**re: Geotechnical Review of Site Servicing Drawings**  
**Proposed Residential Development**  
**Chapman Mills Drive and Riocan Avenue - Ottawa**  
**to: Minto Communities – Mr. Carl Furney - [cfurney@minto.com](mailto:cfurney@minto.com)**  
**to: DSEL – Mr. Alex Tourigny – [atourigny@dsel.ca](mailto:atourigny@dsel.ca)**  
**date: June 27, 2023**  
**file: PG5636-MEMO.02**

Further to your request and authorization, Paterson Group (Paterson) prepared the current memorandum to provide a geotechnical review of the site servicing and grading plans prepared for the proposed residential development to be located at the subject site. The following memorandum should be read in conjunction with the current Geotechnical Investigation Report (Paterson Group Report PG5636-2 Revision 2 dated June 27, 2023).

**PERMISSIBLE GRADE RAISE PLAN**

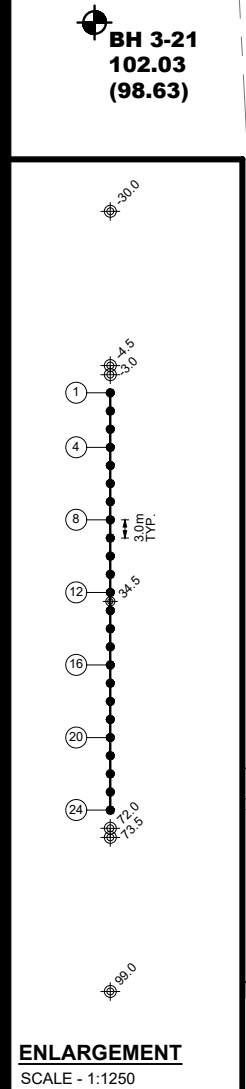
Generally, the subsurface profile consists of fill material underlain by a silty clay crust and/or a glacial till deposit. Where the silty clay deposit was present below the footings of the proposed structures, a permissible grade raise restriction of 2.0 m was provided. Refer to Drawing PG5636-2 – Permissible Grade Raise Areas attached to the present report
